Final Environmental Impact Report/
Final Environmental Impact Statement

Volume III: Responses to Comments

BART-SAN FRANCISCO AIRPORT EXTENSION

VOLUME III: RESPONSES TO COMMENTS ON THE FRDEIR/S#2DEIS

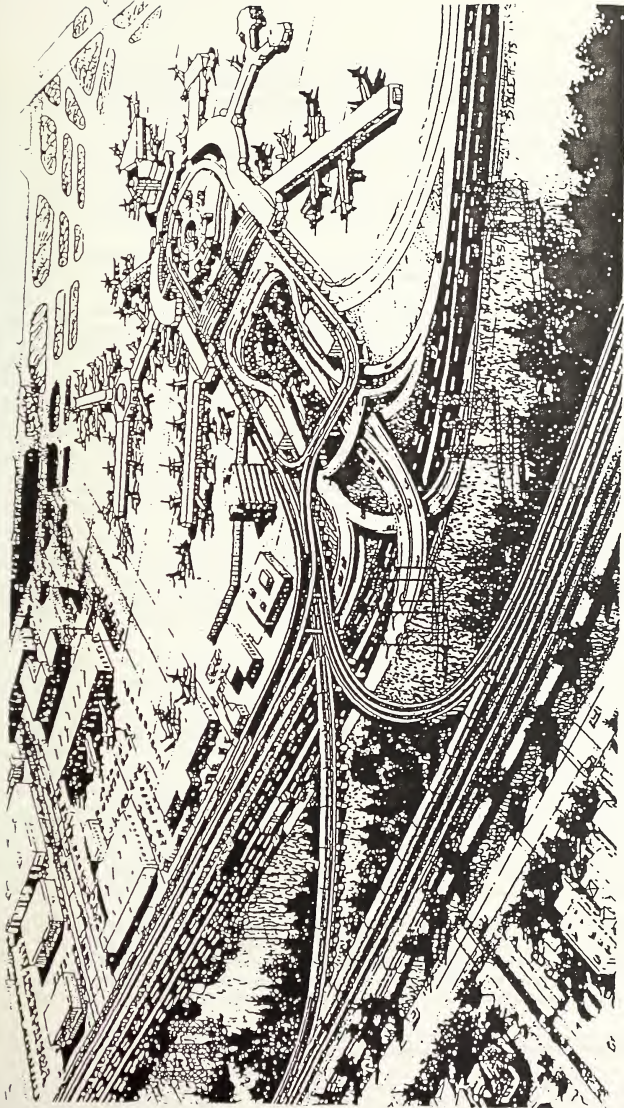
- 7.11. The City requests that the document provide accurate visual simulations of the impact of the “wey stub” aerial structure from northerly Millbrae neighborhoods and propose suitable screening techniques to shield the neighborhoods from visual impact.

Response. Although the written description portrays the visual quality of the structure, the figure on the following page is provided to show the approximate scale and mass of the aerial guideway relative to the open space and Highway 101 ramps. Given the height and mass of the aerial structure, there are no feasible mitigation measures to screen views from neighborhoods in northern Millbrae. This impact is described in paragraph seven, sentence one, on page 3.3-3 of the FRDEIR/S#2DEIS.
